ADDENDUM #1

ISSUE DATE: November 26, 2025

RE: UW-MADISON SCHOOL OF EDUCATION, EDUCATIONAL SCIENCES 12TH FLOOR
RENOVATION UNIVERSITY OF WISCONSIN - MADISON
UW- Madison Project No. 0154-2321 / UWSA Project No. A-23-017

Support Room (IT) Room 1292 photos

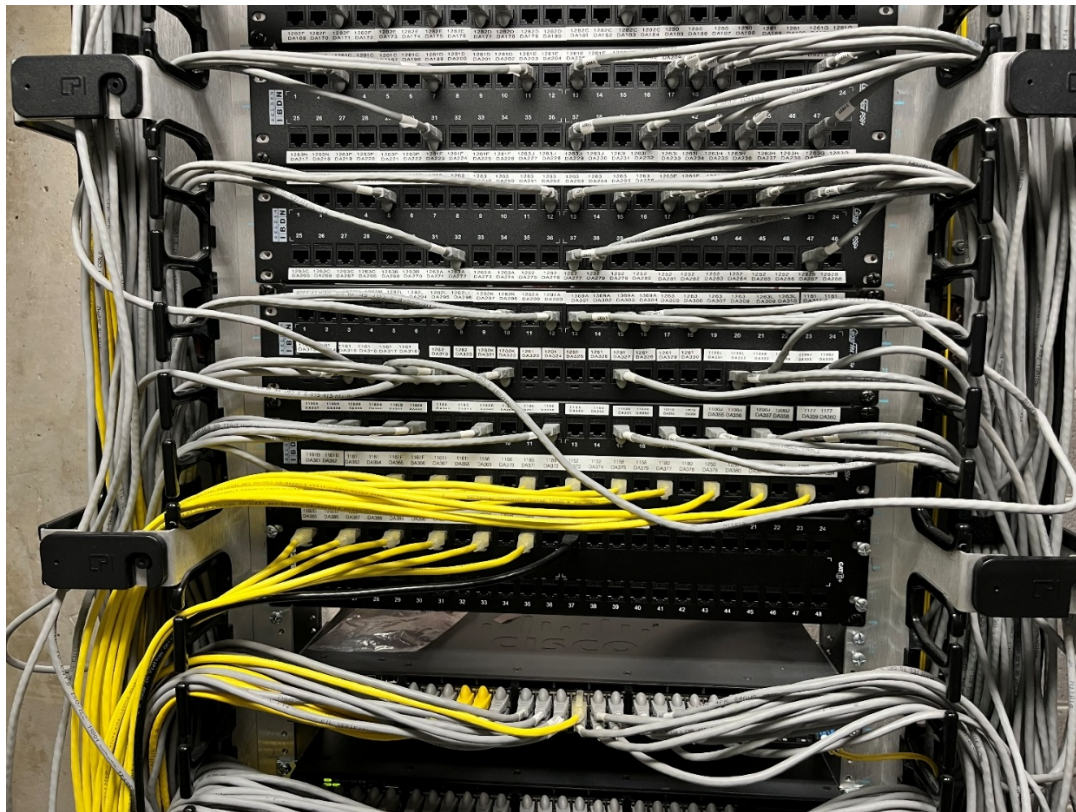
4. At the Pre-Bid walk-through on November 19, 2025, the IT Closet on the 12th Floor was locked and we were not able to see that space. Can you provide any photos of Support Room (IT) 1292?

Answer: See attached photos at the end of this Addendum.
